VICKERY EXTENSION PROJECT

RESPONSE TO INDEPENDENT PLANNING COMMISSION POINTS OF INTEREST
RECEIVED 7 AND 8 FEBRUARY 2019

MARCH 2019
Project No. WHC-15-33
Document ID: 00967833

Figure 1

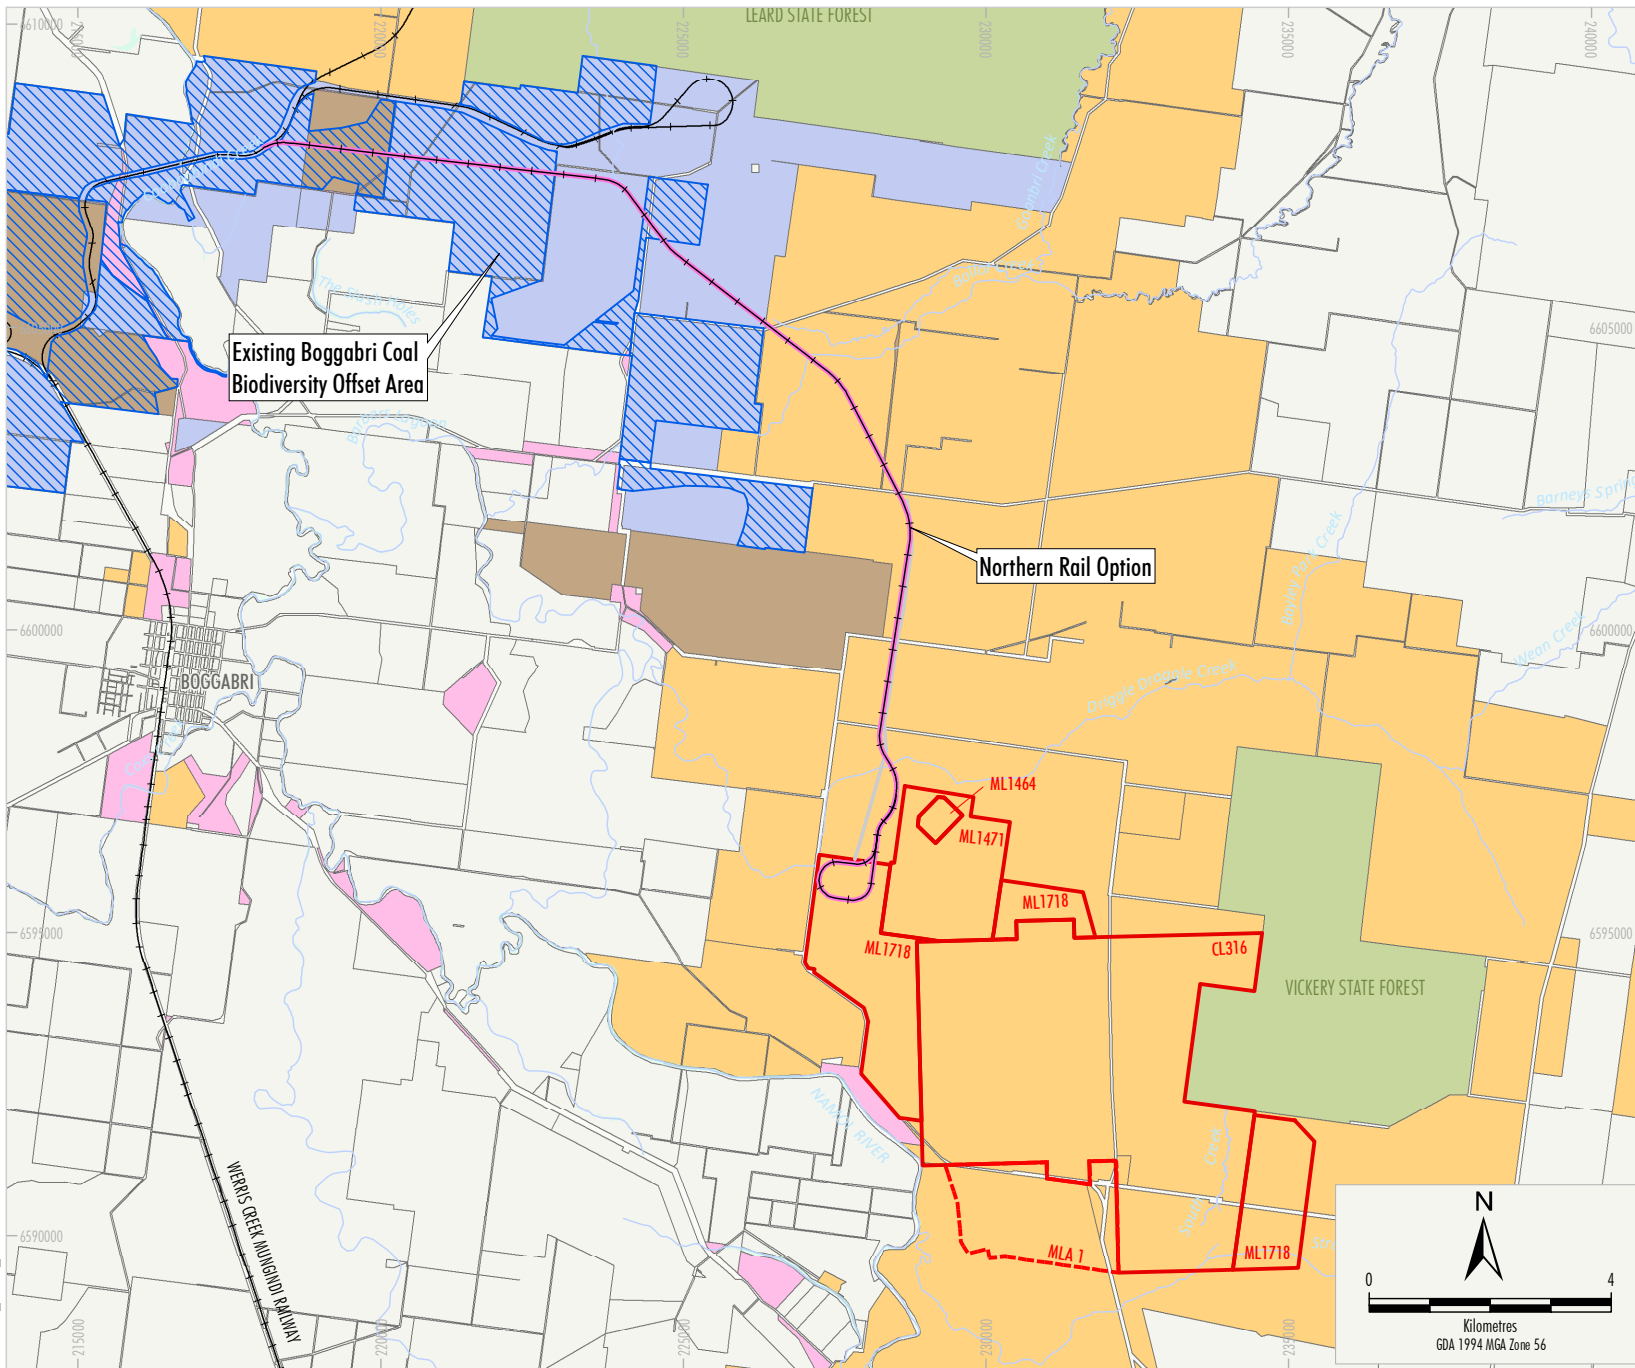
Details of the assessment of all rail options & particularly the northern loop, providing assumptions and specific reasons for conclusions.

More explicit arguments need to be provided re the infeasibility of the northern route (e.g. the 2014 EIS indicates that Tarrawonga was to share the Boggabri Mine loading facilities but no commercial agreement could be reached, suggesting that the route can technically carry more coal than its current usage). Are there engineering issues or economic, or something else?

- Private land access:
 - Whitehaven does not own all private land required for the northern rail option (Figure 1), whereas Whitehaven owns all private land required for the Project rail spur (or a land access agreement is already in place).

- The Project rail spur would result in the avoidance of impacts to existing Boggabri Coal Mine biodiversity offset areas (Figure 1). Note Whitehaven isn't a participant of the joint venture for the Boggabri Coal Mine private rail spur and the capacity constraints outlined above for the Common Section also apply. Hence, the Project rail spur could not be realigned to connect directly with the Boggabri Coal Mine private rail spur to avoid impacts to the existing offset areas.

Figure 2

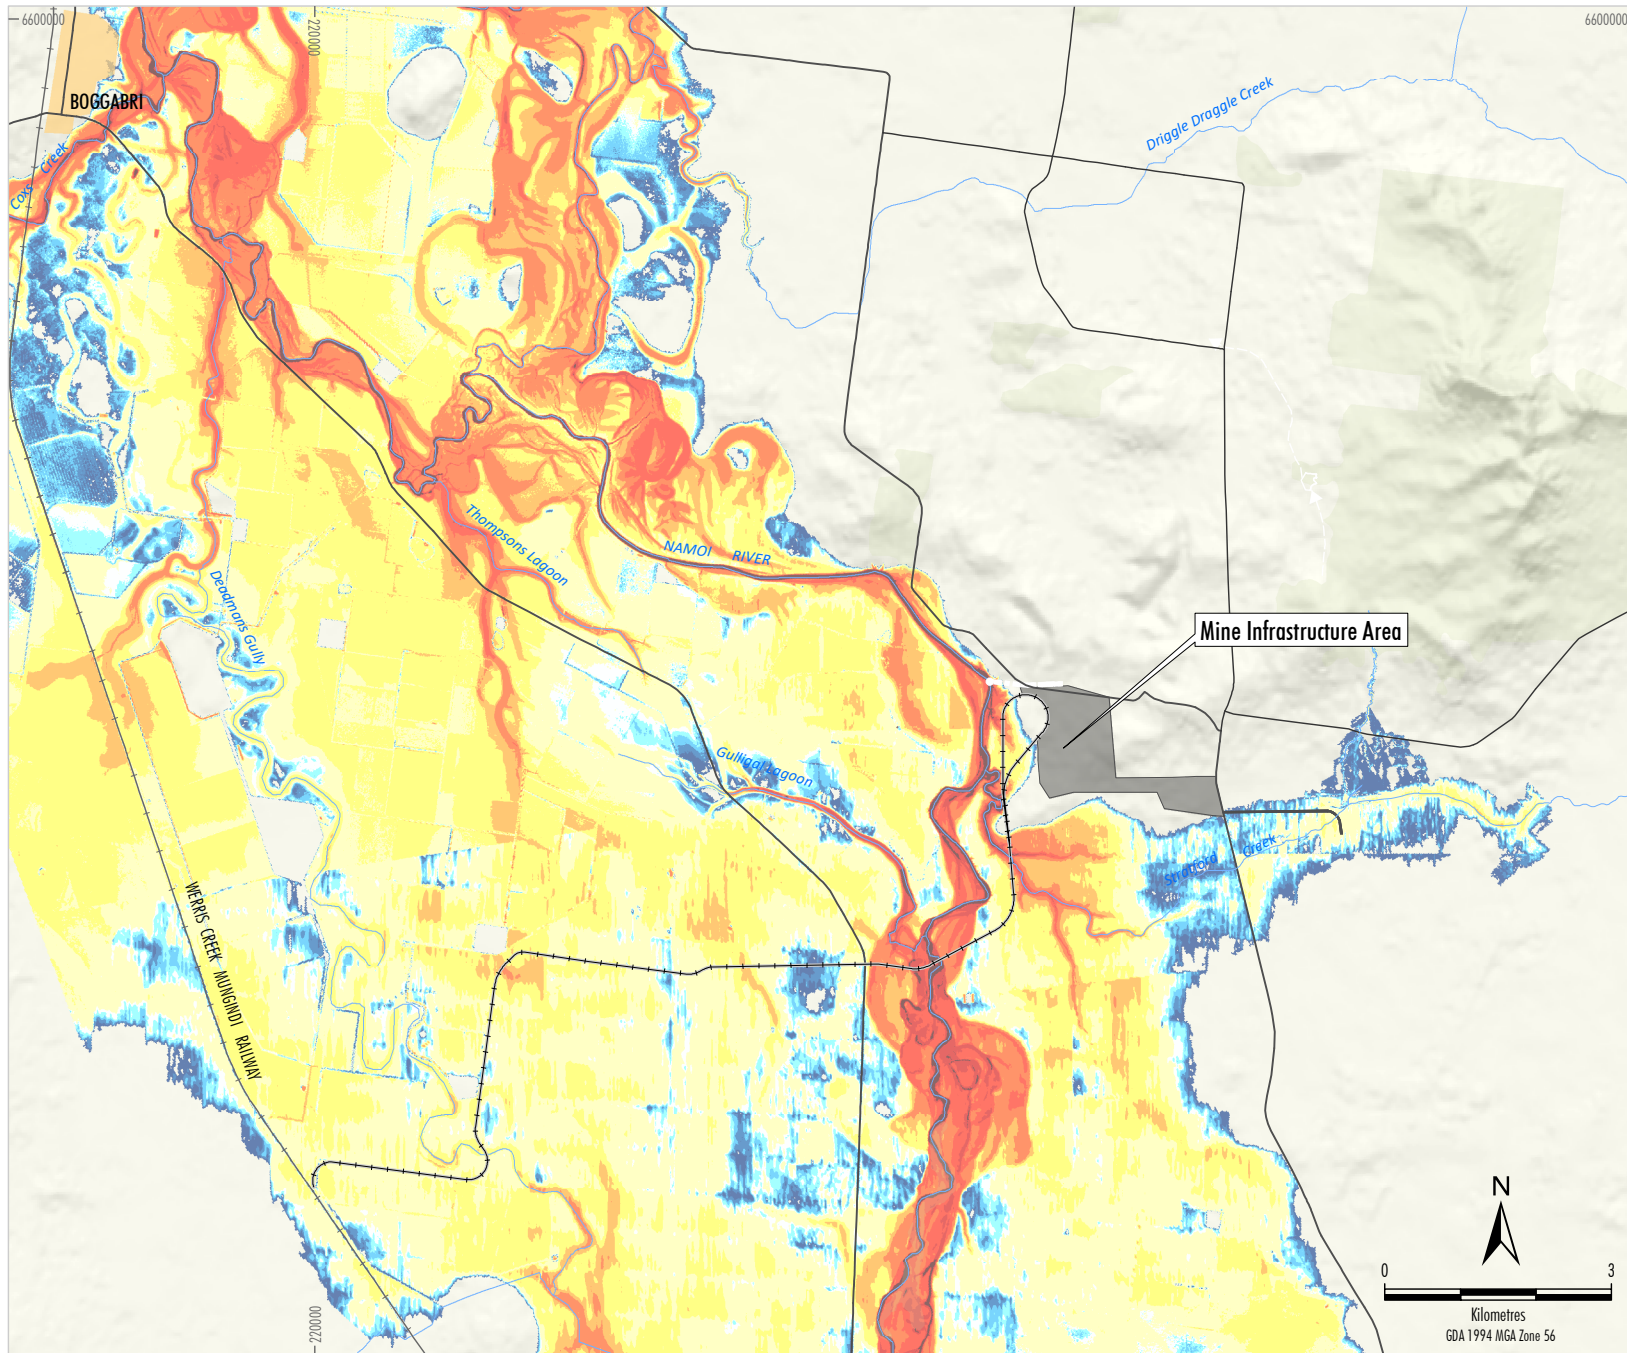
What is the sensitivity of the predicted incremental flood levels (above or below that would occur without the rail spur) at the CHPP and junction with the North-west main line to changes in the flood plain hydraulics parameters?

The mine infrastructure area (including the Project CHPP) is located outside the extent of the 1 in 100 year design flood event for the Namoi River (Figure 2), as well as three times the Namoi River 1 in 100 year design flood event (WRM Water & Environment, 2018). The rail level of the Main Line is also not overtopped at the proposed junction with the Project rail spur for a flood event that is three times the 1 in 100 year event. Peak flood levels for three times the 1 in 100 year flood event are up to 1 m higher than the 1 in 100 year flood event. Given this, changes in floodplain roughness would not impact on the flood immunity of the Project CHPP or at the junction with the Main Line.

Figure 13

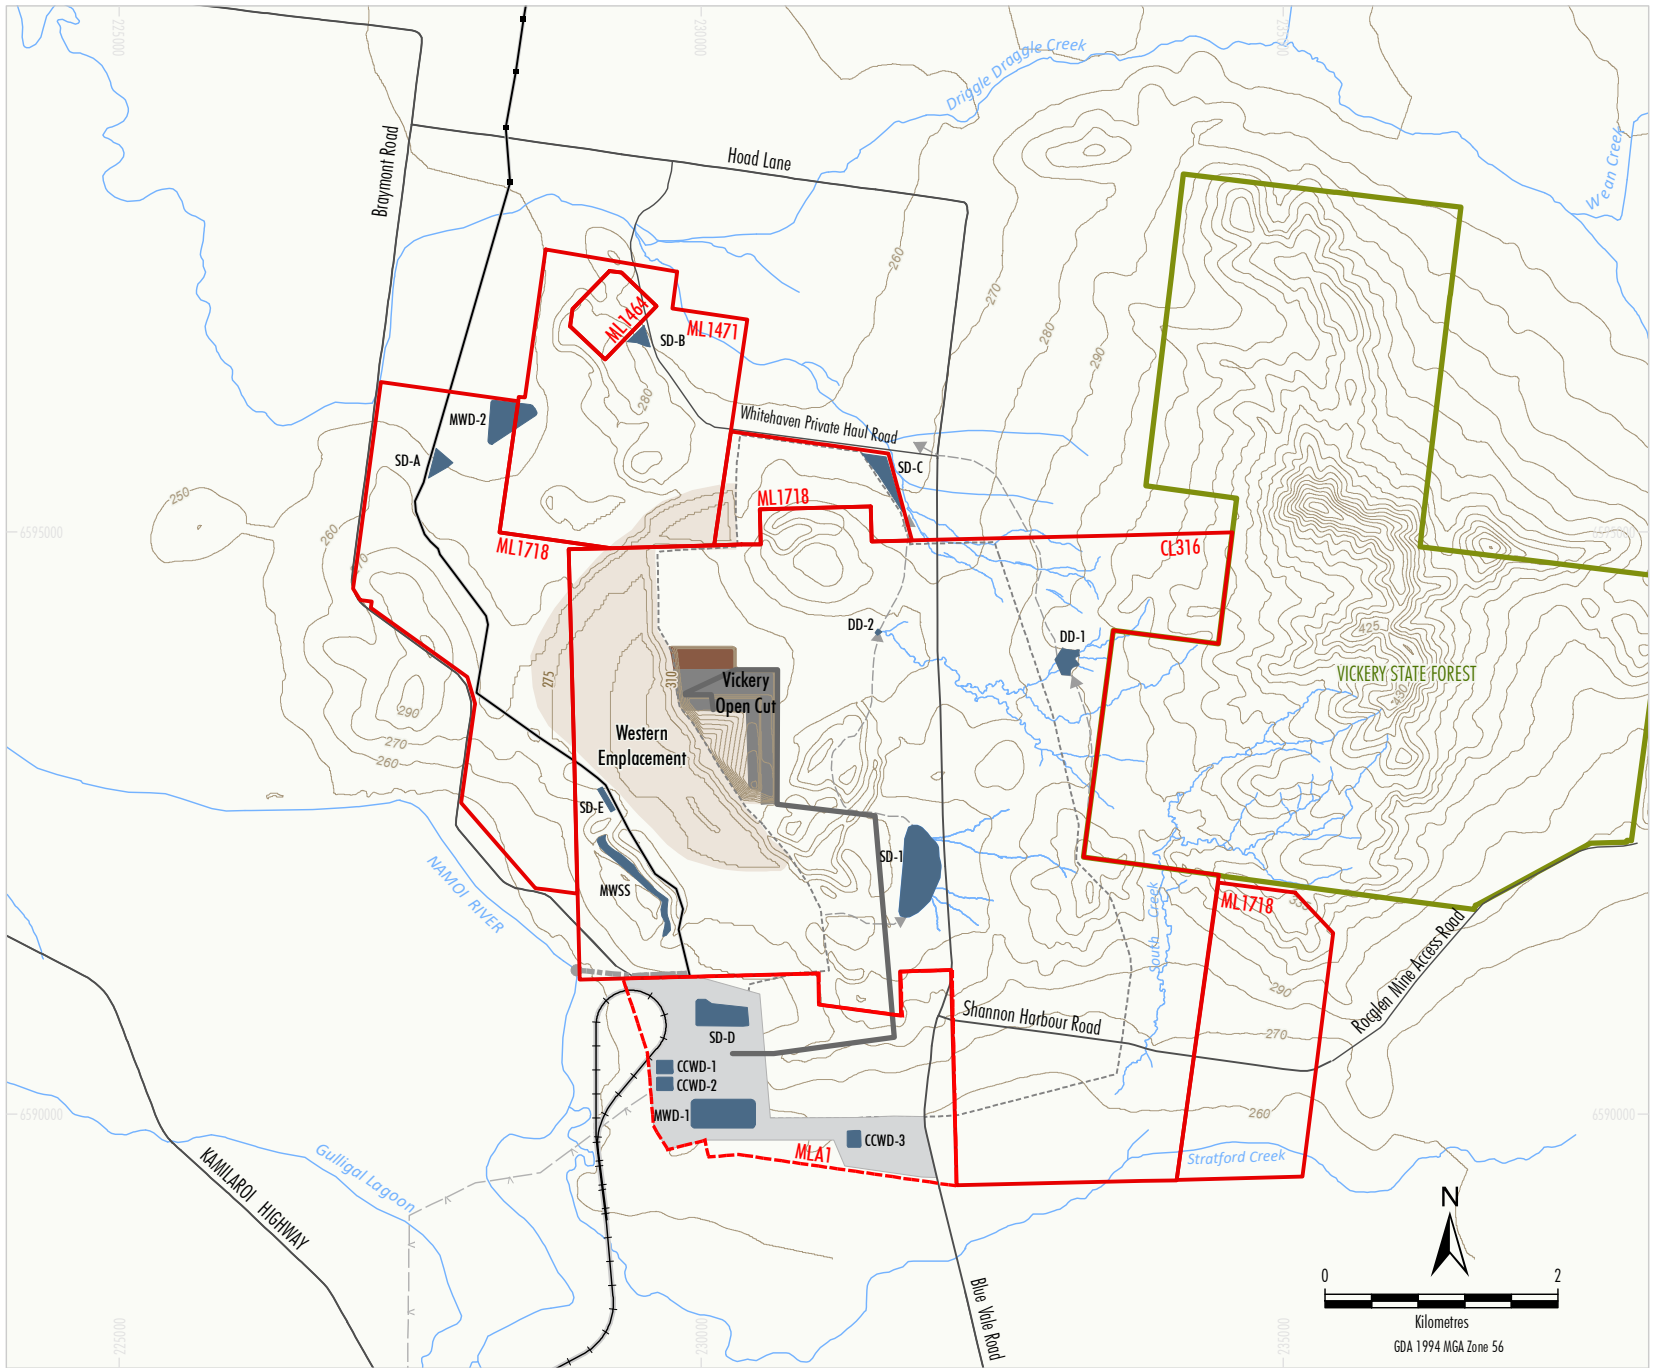
Questions have been raised about the noise modelling contours. Can the proponent demonstrate that their approach gives valid results for similar scenarios at their other local mine sites (i.e. show that their modelling works)? What is the sensitivity of the predictions to changes in noise assumptions?

- Project Year 3 – representative of initial operations (i.e. mining operations in the north-west and central portions of the open cut and waste rock emplacement at the Western Emplacement) (Figure 13);
- Project Year 7 – representative of ongoing operations (i.e. mining operations in the eastern portion of the open cut and waste rock emplacement at the Western Emplacement) (Figure 14); and
- Project Year 21 – representative of ongoing operations i.e. mining operations in the southern portion of the open cut) (Figure 15).
